# Work Order ID 99572

Item Name: Replacement Skidtube

| DRAWING NO.<br>D2580 | TITLE<br>205 SKIDTUBE ASSEMBLY | REV. E                 | DART AEROSPACE LTD<br>ENGINEERING ORDER |  | D.E.O. NO.<br>D2580-E-1 | SHEET NO.<br>SHEET 1 OF 1 | SCALE<br>NTS |

CHANGE ALL C'BORED WELDED CROSSBOLT SPACERS TO SWAGED SPACERS

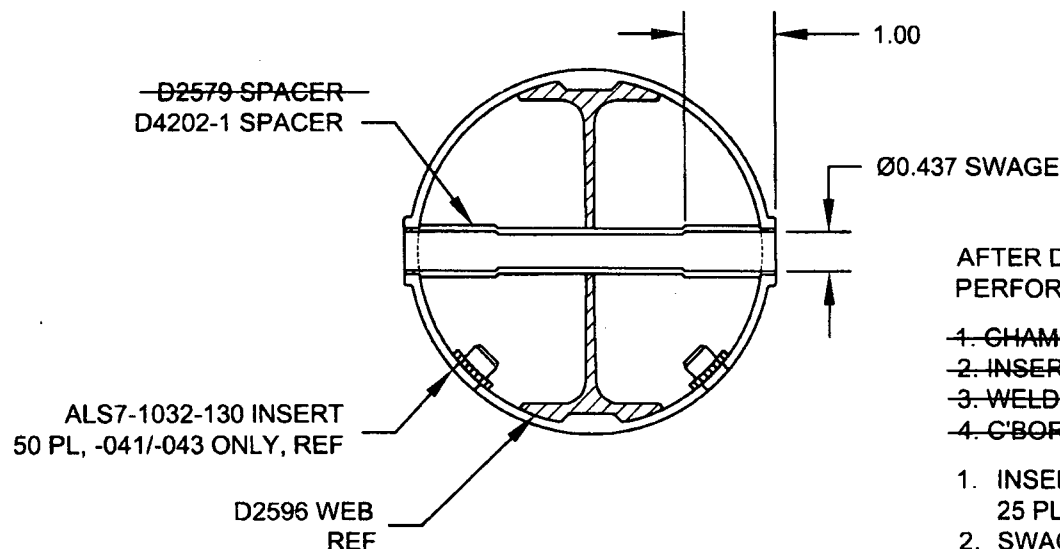
| QTY  | QTY  | QTY  | PART NUMBER | DESCRIPTION       |
|------|------|------|-------------|-------------------|
| 20   | 24   | 25   | D2579       | CROSS BOLT SPACER |

|    | 4  |    | * D2579 | CROSS BOLT SPACER |
| 20 | 20 | 25 | D4202-1 | SPACER            |

WELD 4X D2579 SPACERS PER DWG  
IN LOCATIONS MARKED "NO C'BORE".  
REF SHEET 4 OF DWG.
